**Committee of Experts on the Transport of Dangerous Goods
and on the Globally Harmonized System of Classification
and Labelling of Chemicals****Sub-Committee of Experts on the Transport
of Dangerous Goods****Forty-ninth session**

Explosives and related matters: miscellaneous**Clarification of the classification of ammonium nitrate based
fertilizers – draft amendments to the Model Regulations and
the Manual of Tests and Criteria****Transmitted by the expert from Sweden¹****Introduction**

Draft new Section 39 for the Manual of Tests and Criteria

Figure 39.5.1 Flowchart for the classification of ammonium nitrate based fertilizers

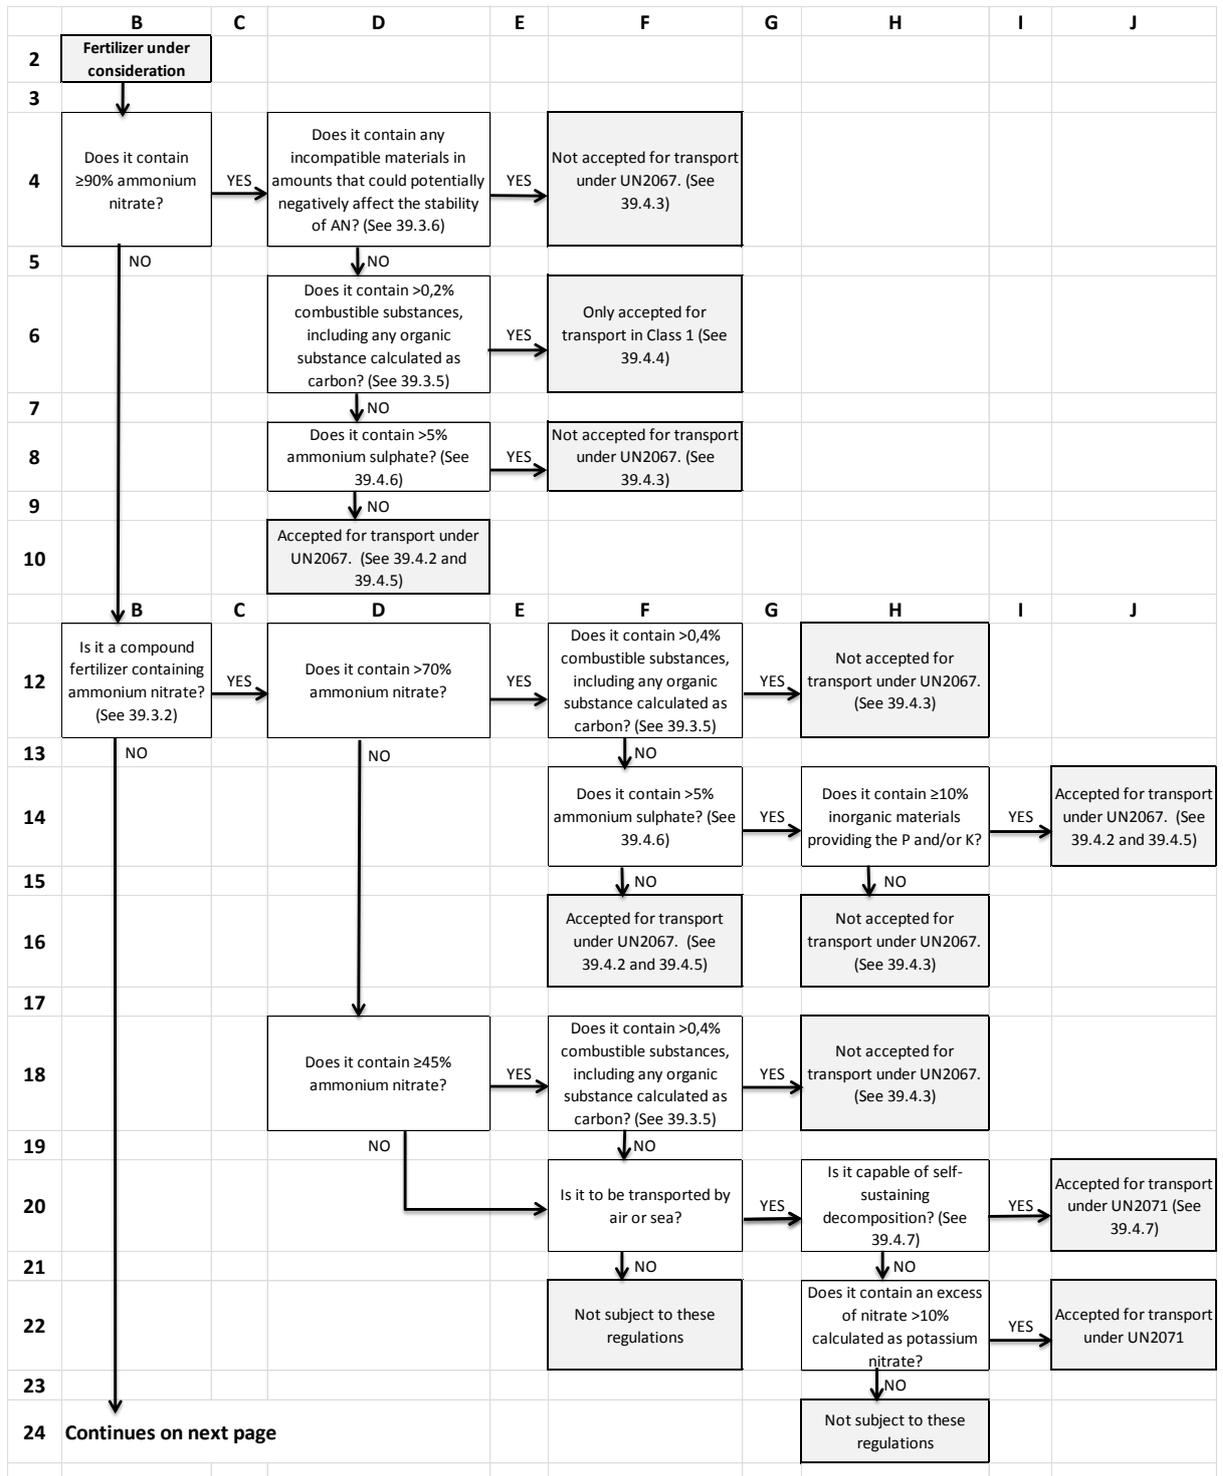
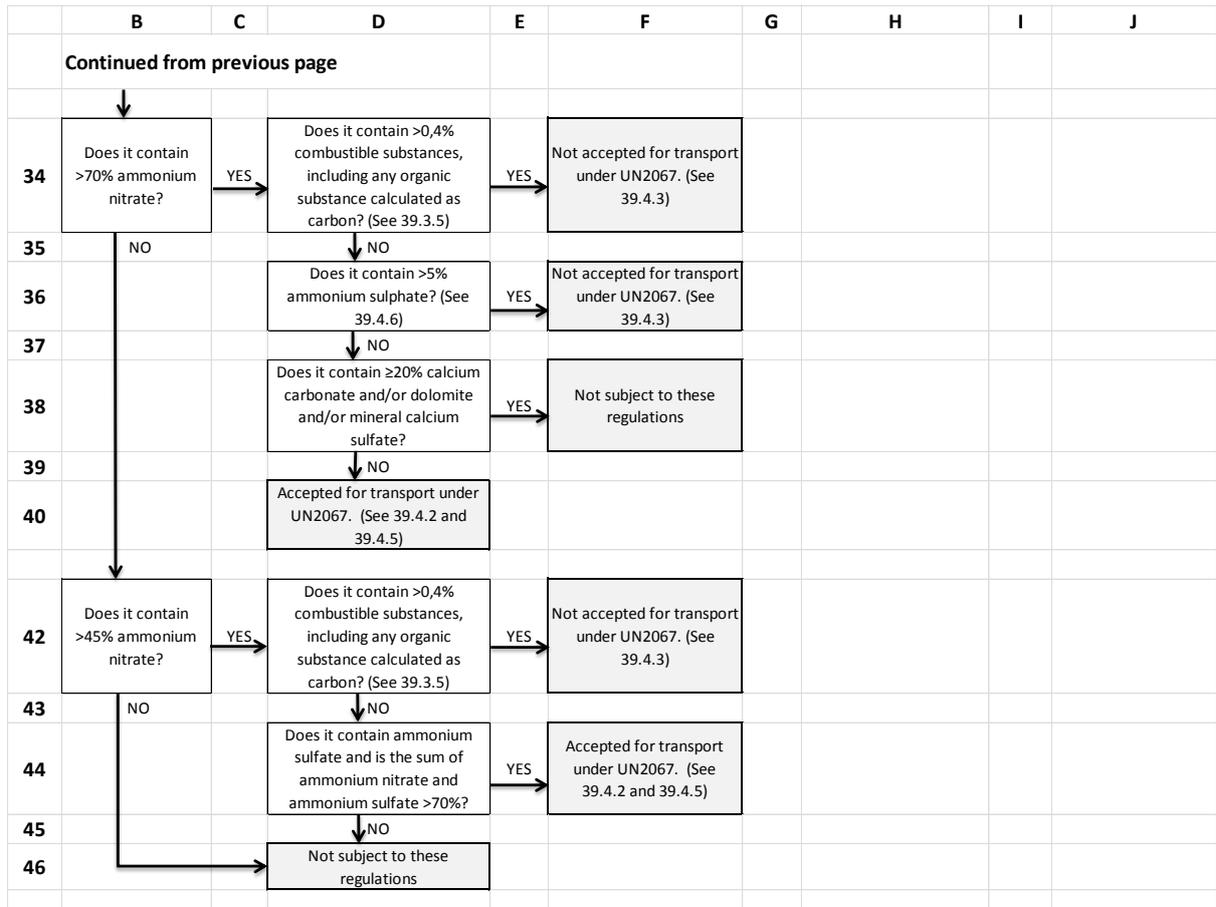
39.5.1 Ammonium nitrate based fertilizers shall be classified in accordance with the flowchart below.
